HISTORIC AND DESIGN REVIEW COMMISSION

HDRC CASE NO: 2021-376
ADDRESS: 5330 SAN PEDRO AVE
LEGAL DESCRIPTION: NCB 9008 BLK 4 LOT 100
ZONING: C-2, H
CITY COUNCIL DIST.: 1
DISTRICT: Olmos Park Terrace Historic District
APPLICANT: Armia Mazaheri/Donia Enterprises LLC
OWNER: Ali Mazaheri/Donia Enterprises LLC
TYPE OF WORK: Window replacement, exterior modifications, repairs
APPLICATION RECEIVED: July 28, 2021
60-DAY REVIEW: Not applicable due to City Council Emergency Orders
CASE MANAGER: Rachel Rettaliata

5330 SAN PEDRO
HDRC SUBMITTAL
SAN ANTONIO , T X

1 EXISTING FRONT ELEVATION
EXISTING HOUSE

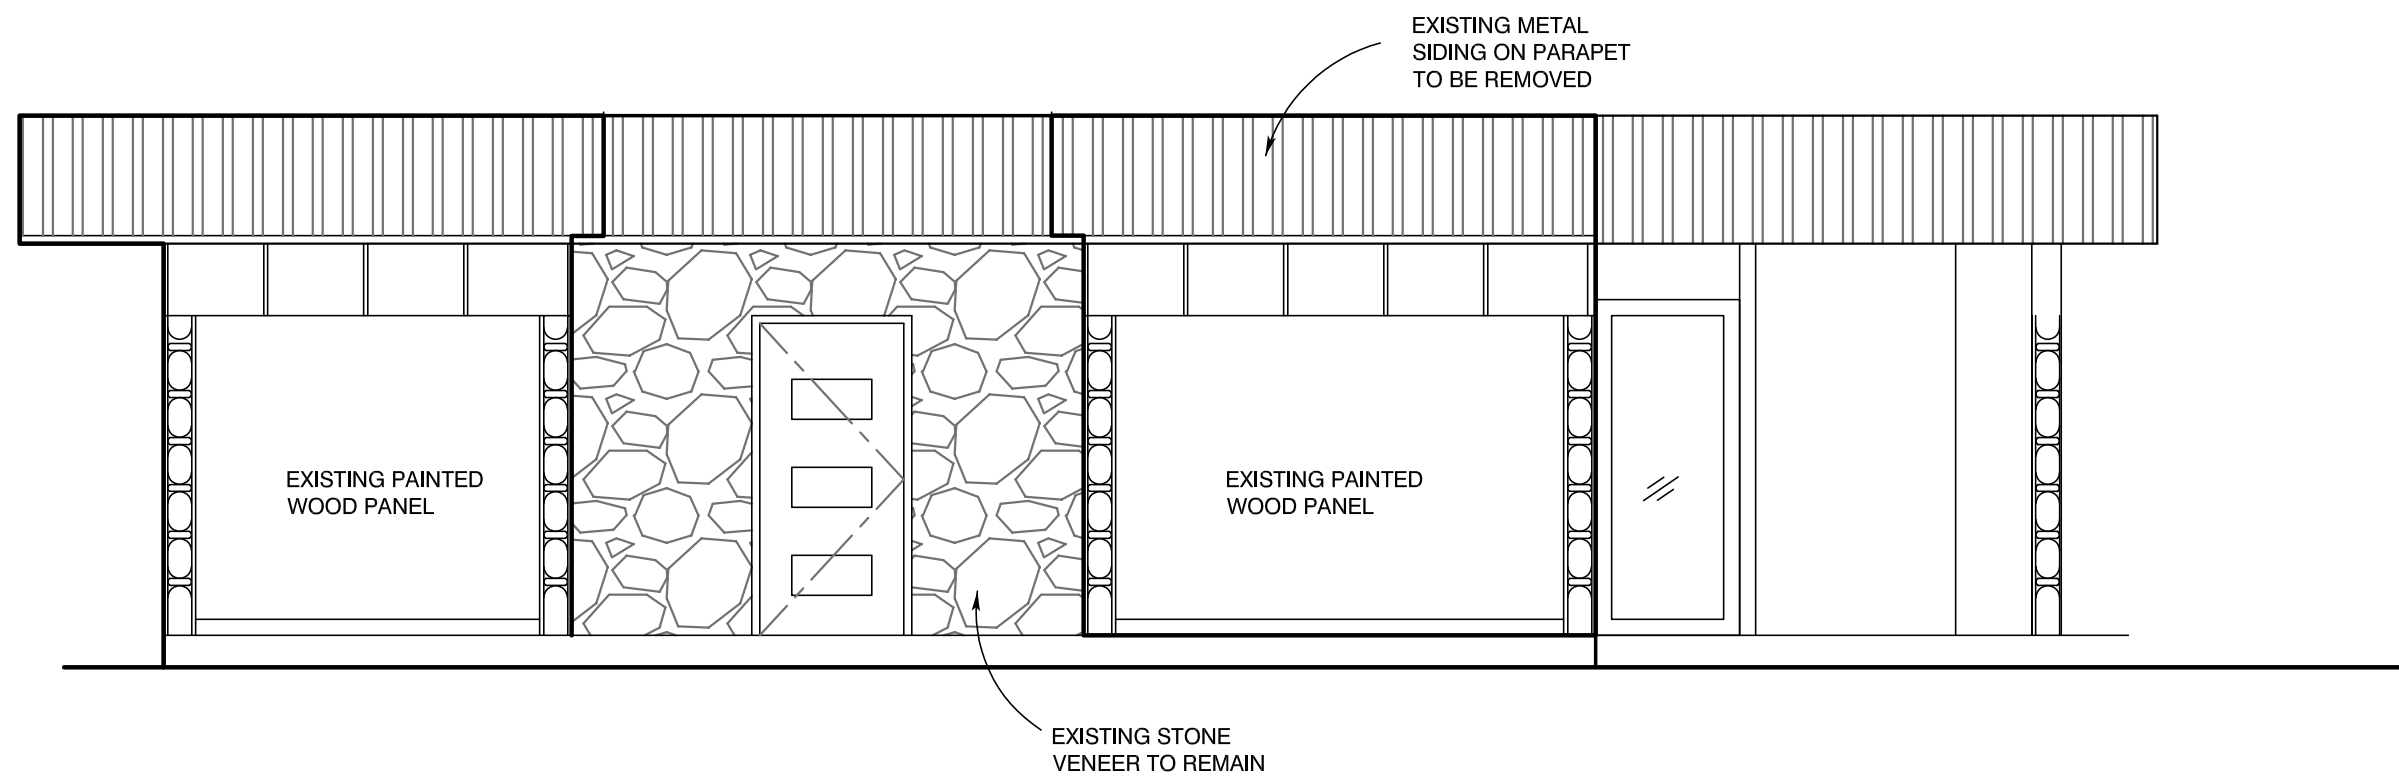
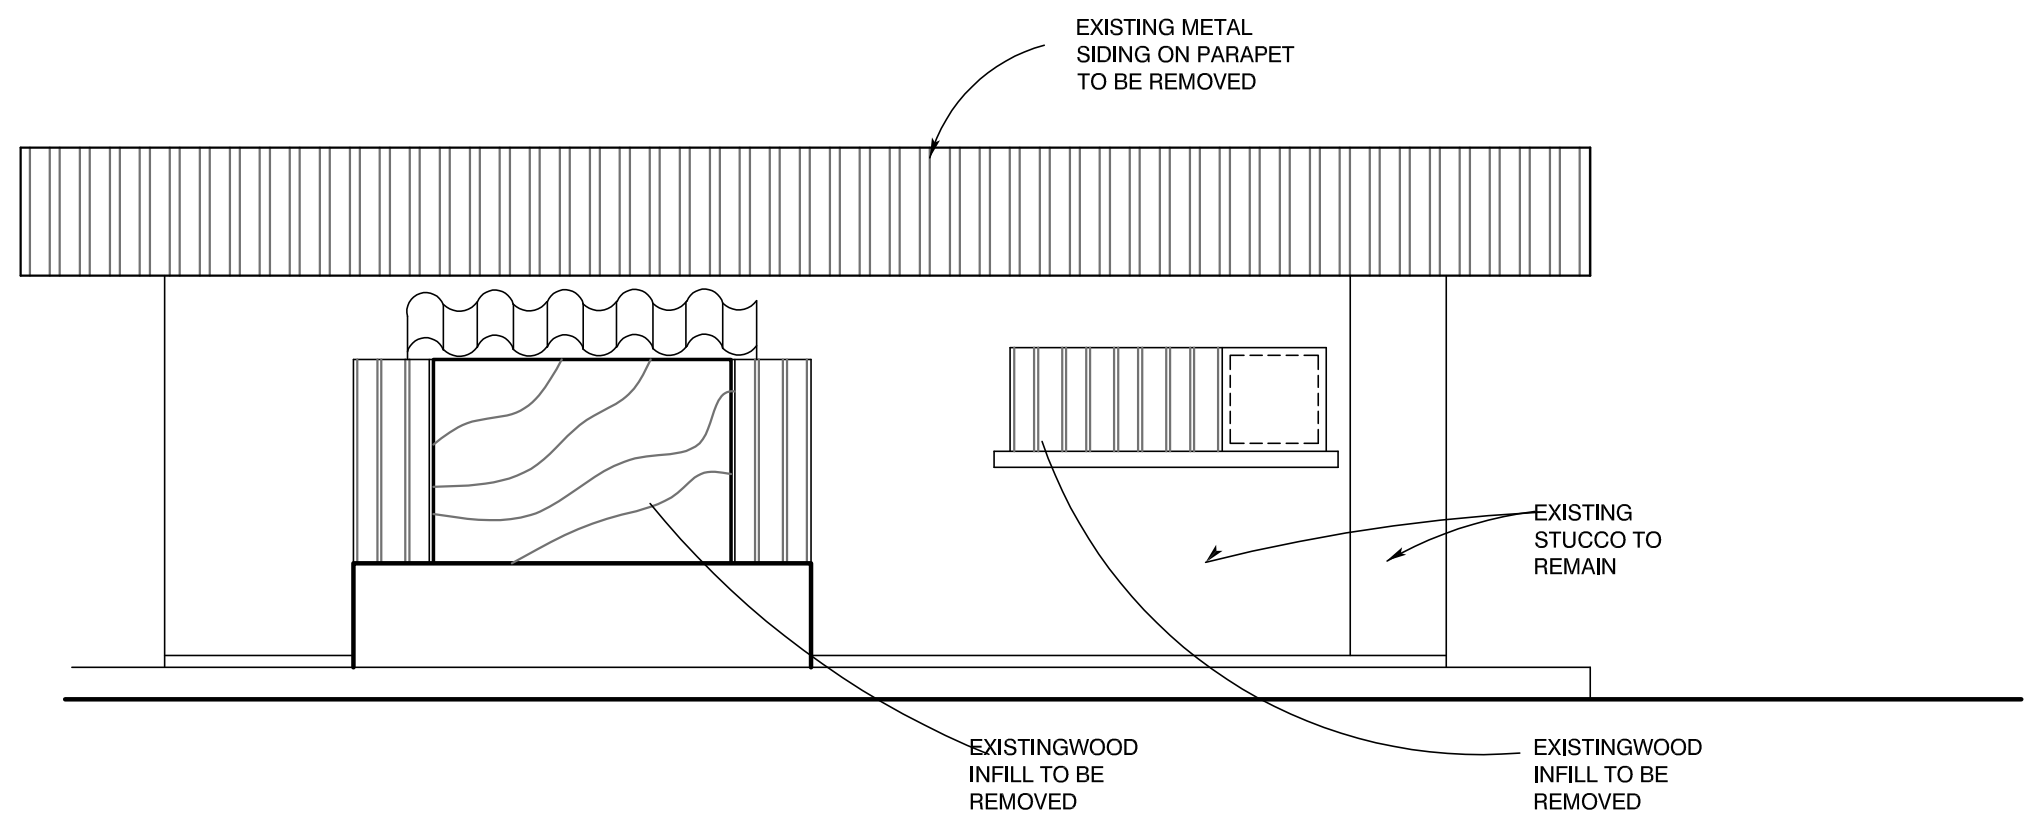
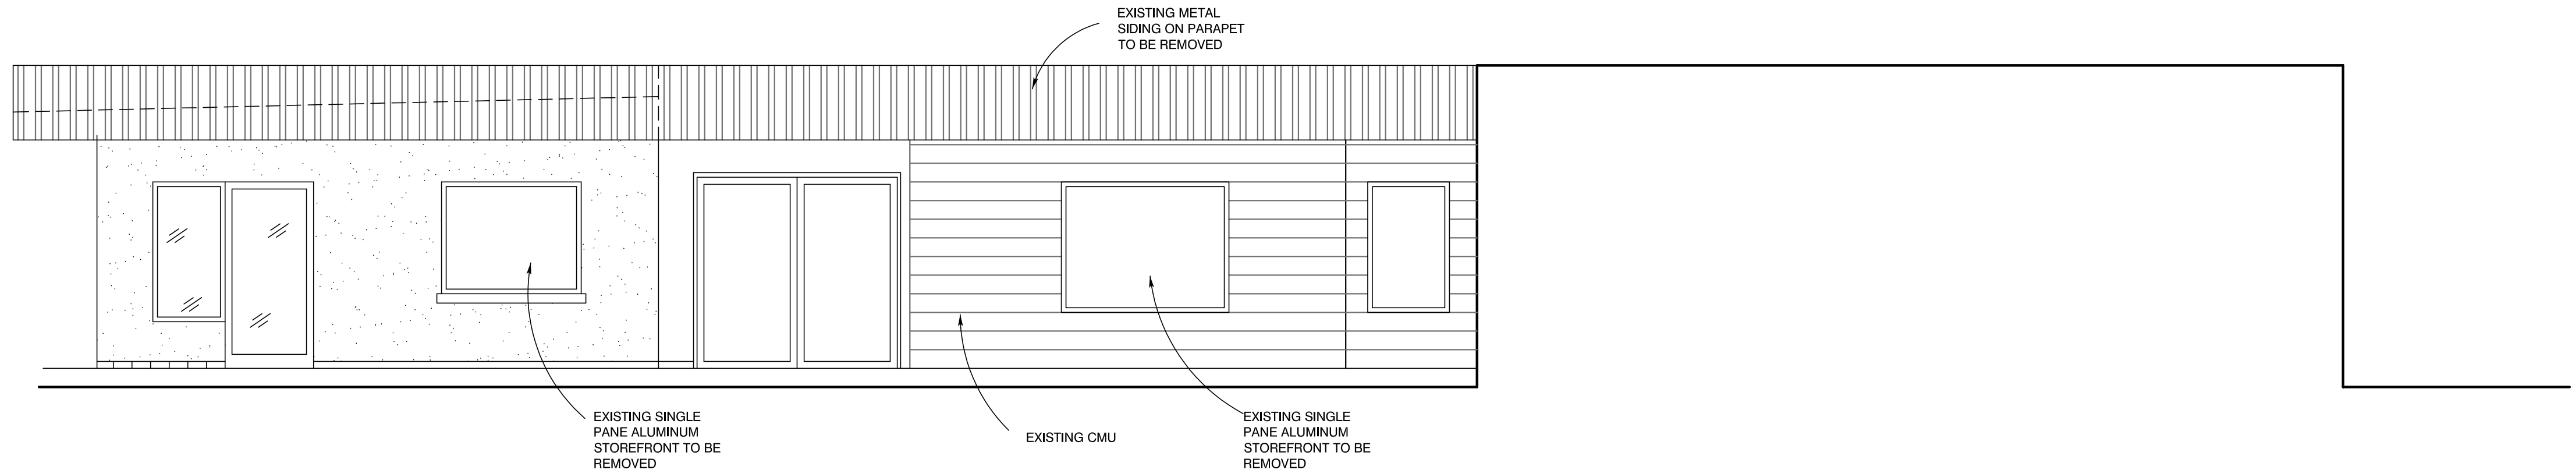
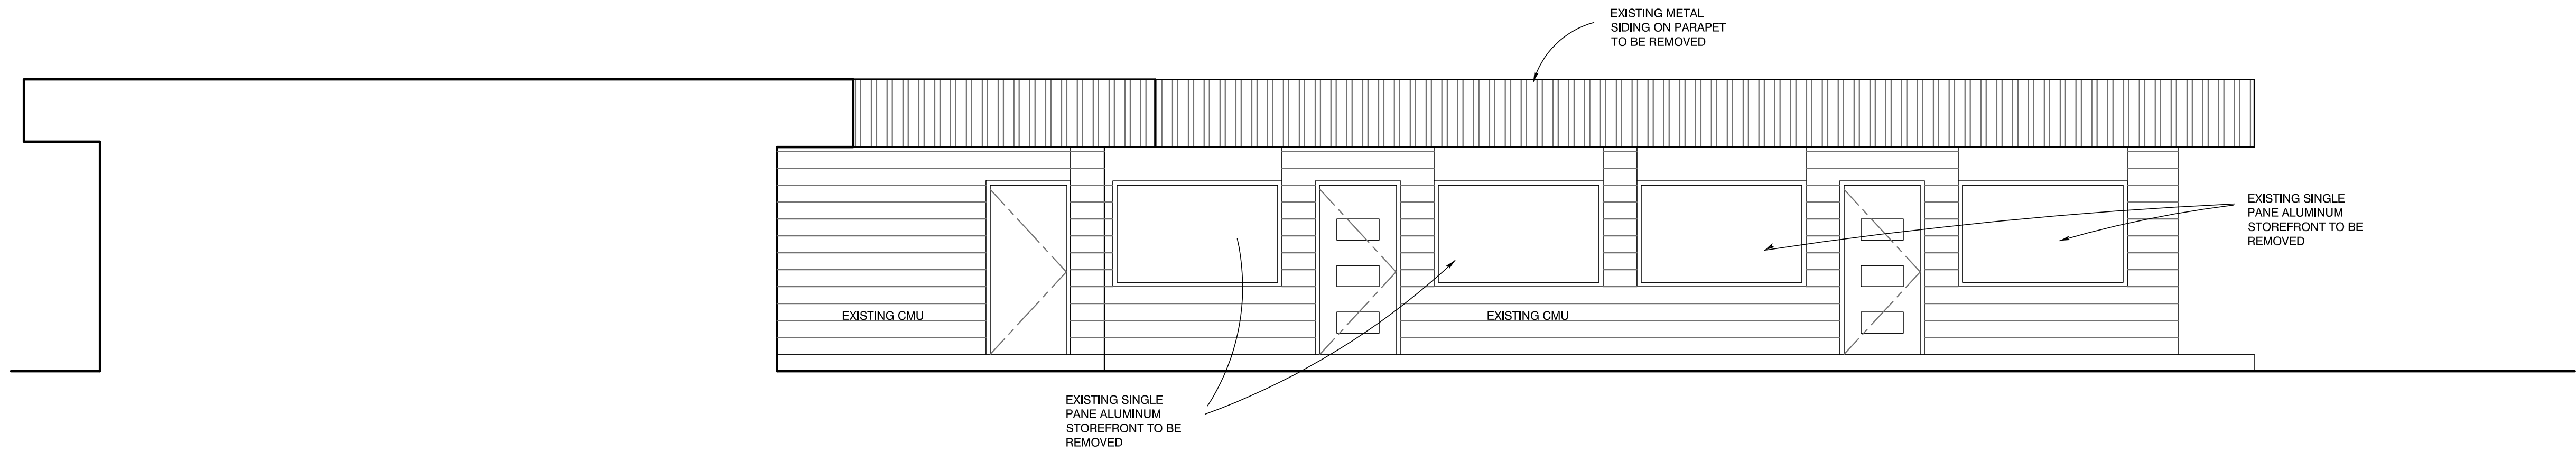
- d. METAL PARAPET REPLACEMENT – The applicant has proposed to replace the metal parapet awning with a 4-foot stucco parapet surrounding the perimeter of the structure. Guideline 10.A.i for Exterior Maintenance and Alterations states that applicants should preserve character-defining features such as cornice molding, upper-story windows, transoms, display windows, kickplates, entryways, tiled paving at entryways, parapet walls, bulkheads, and other features that contribute to the character of the building. Staff finds that retaining the modified parapet walls with stucco will be in keeping with the character of the structure. Staff finds the proposal appropriate.

5. For the raising of the façade; stucco might be an appropriate material. We would just need a drawing showing how that would look and I can review with senior staff.

Response : Please refer to the attached Existing and New building elevations indicating the scope of work and modifications requested. The request is to remove the existing deteriorated metal panel parapet and replace it with stucco which is more in character with the existing building.

2 NEW FRONT ELEVATION
EXISTING RETAIL

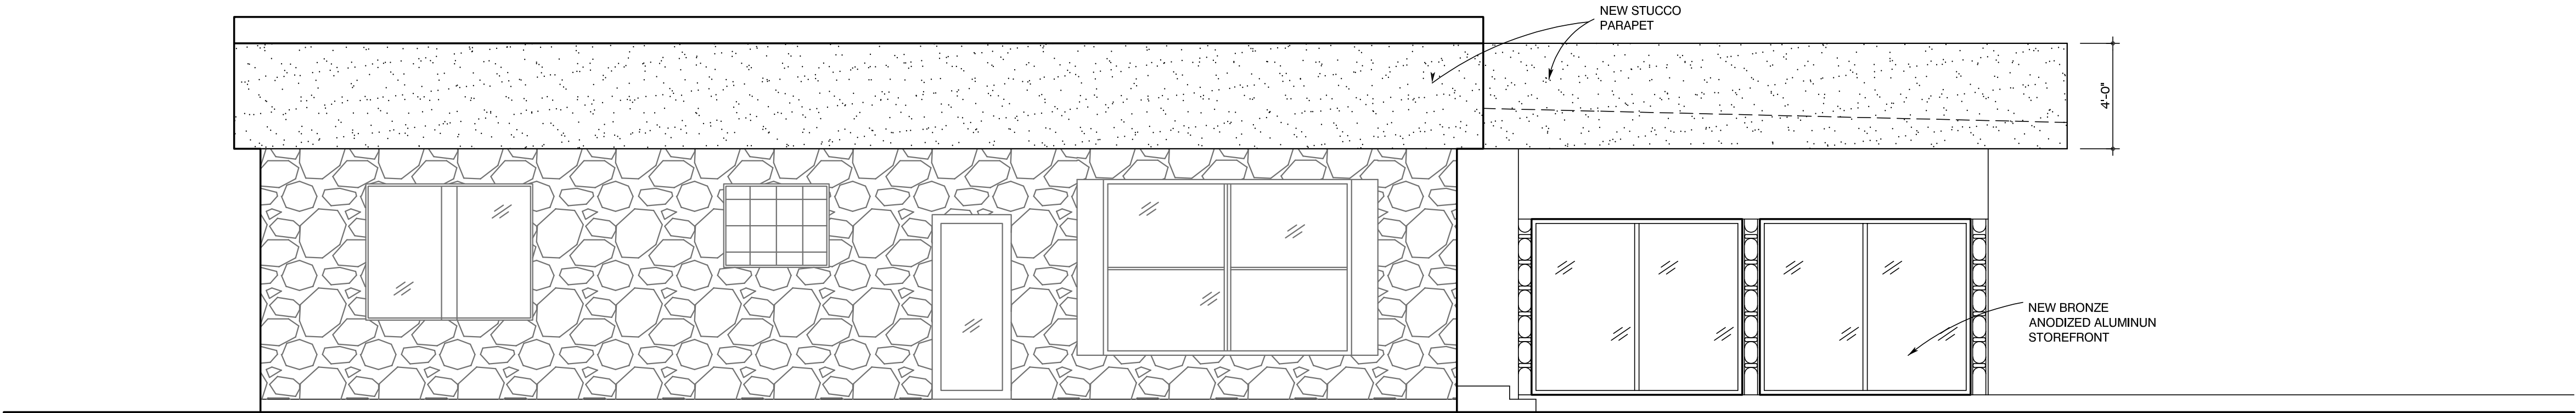
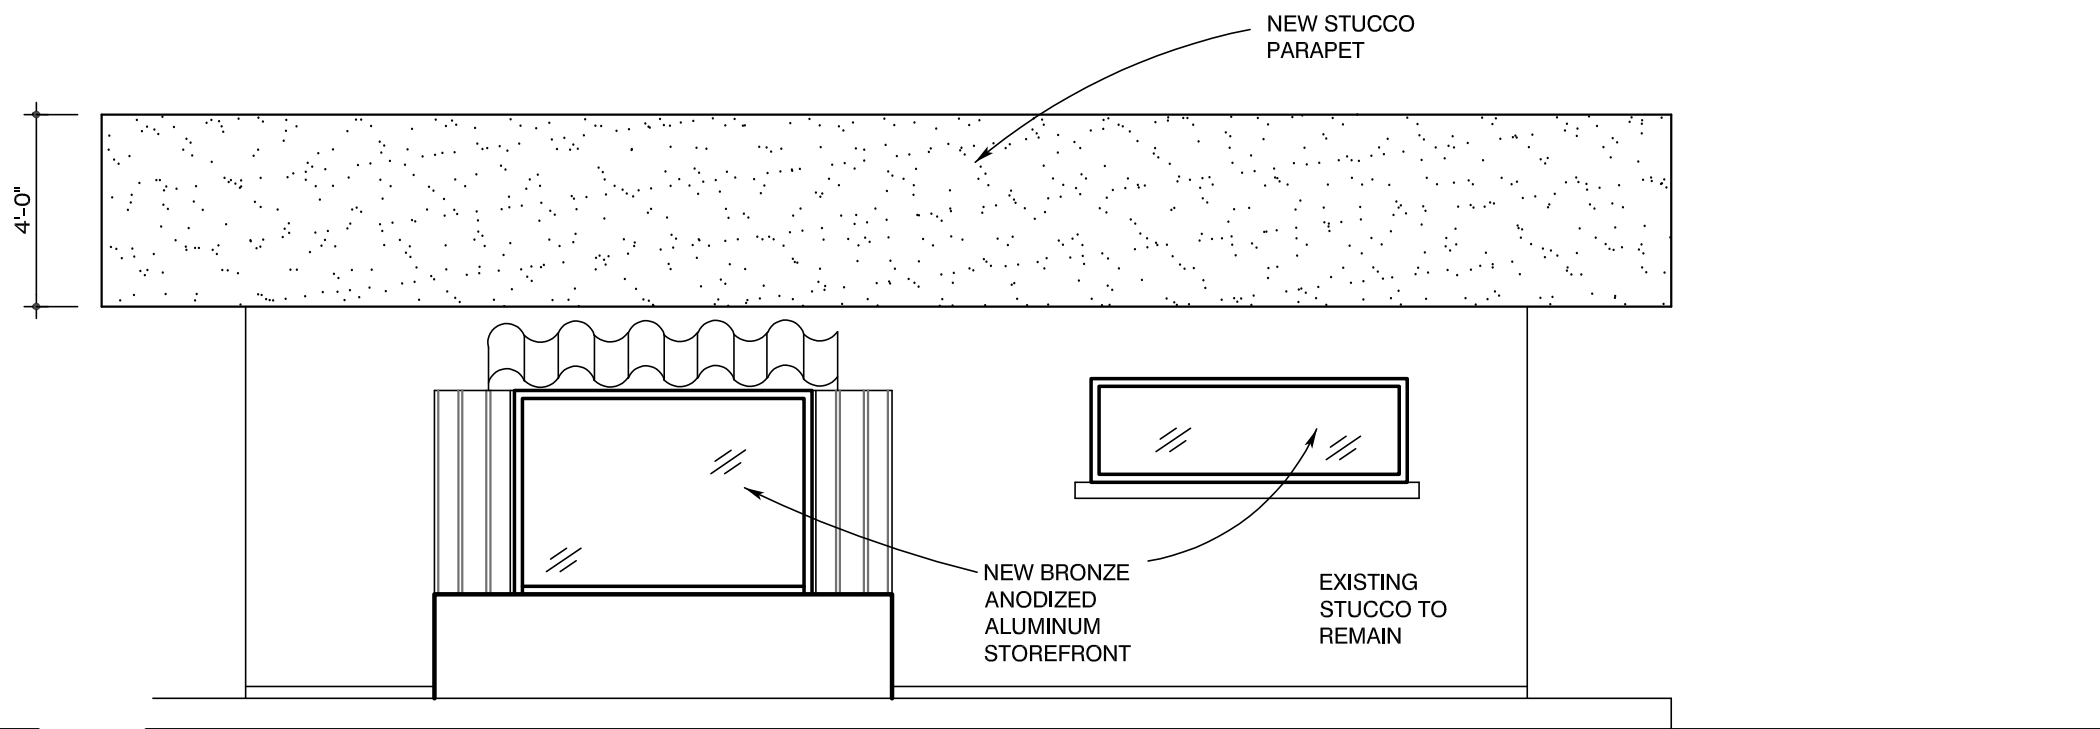
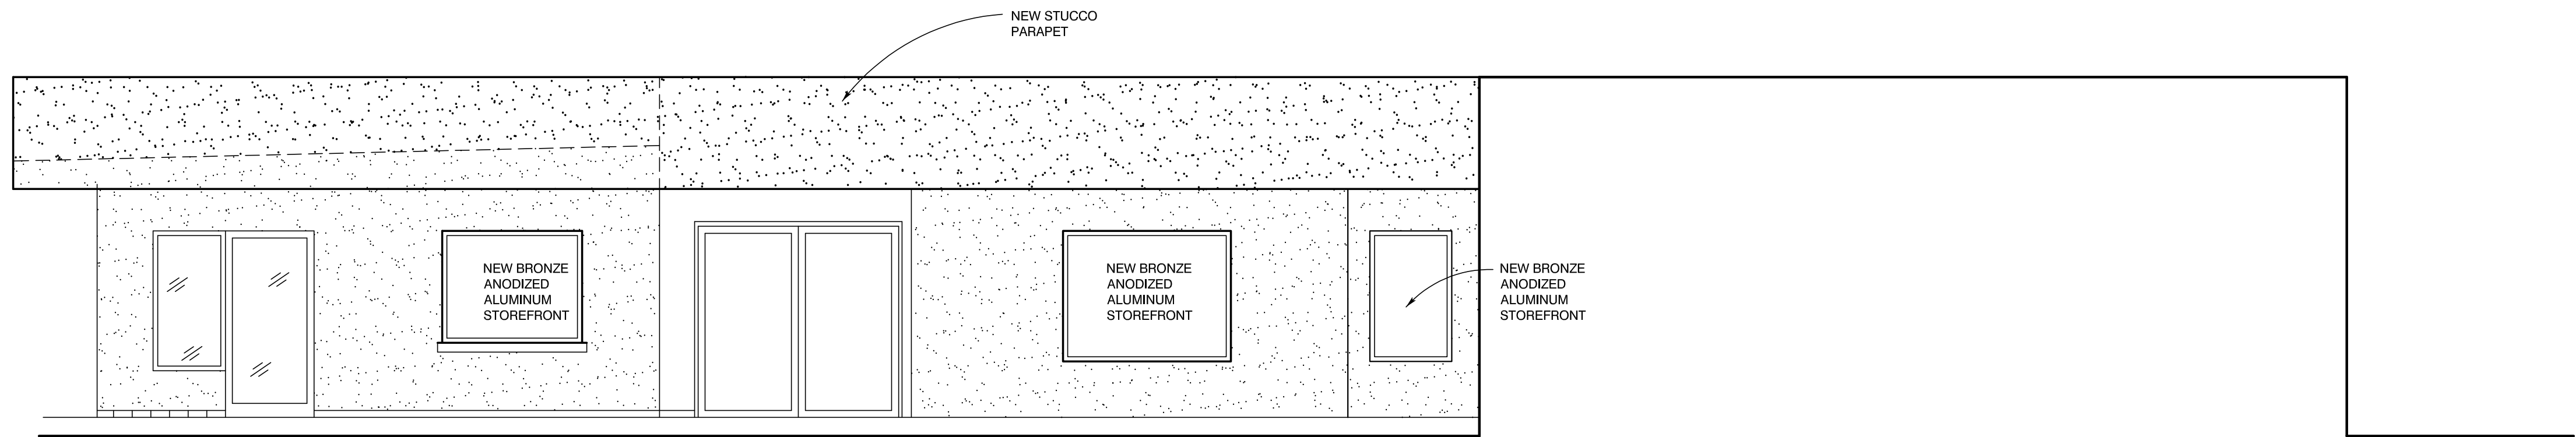
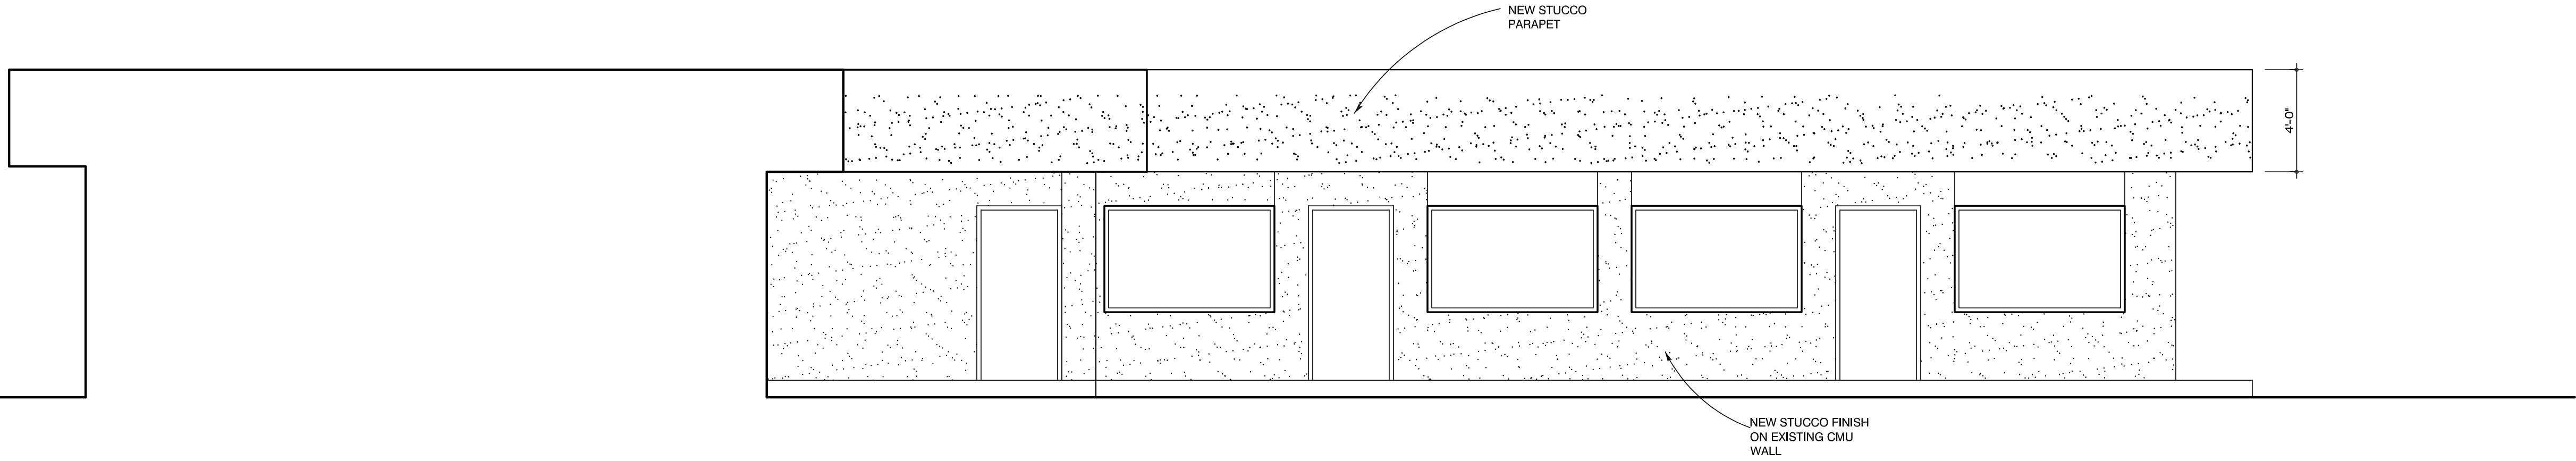
- c. STUCCO CLADDING INSTALLATION – The applicant has proposed to install stucco cladding over the painting cinder block exterior walls to match the existing stucco exterior. Guideline 10.A.iv for Exterior Maintenance and Alterations states that applicants should use in-kind materials or materials appropriate to the time period of the original commercial facade when making repairs. The applicant will not modify the existing stone cladding. Staff finds the proposal appropriate.

4. To scale elevation drawings of the building that illustrate the center block area where you want to add stucco and any other modifications that may be proposed. We need to understand the visual impact of what is proposed. **Response : Please refer to the attached Existing and New building elevations indicating the scope of work and extent of new stucco finish to match the existing stucco finish. We feel this will help unify the building and is more in character with the existing design.**
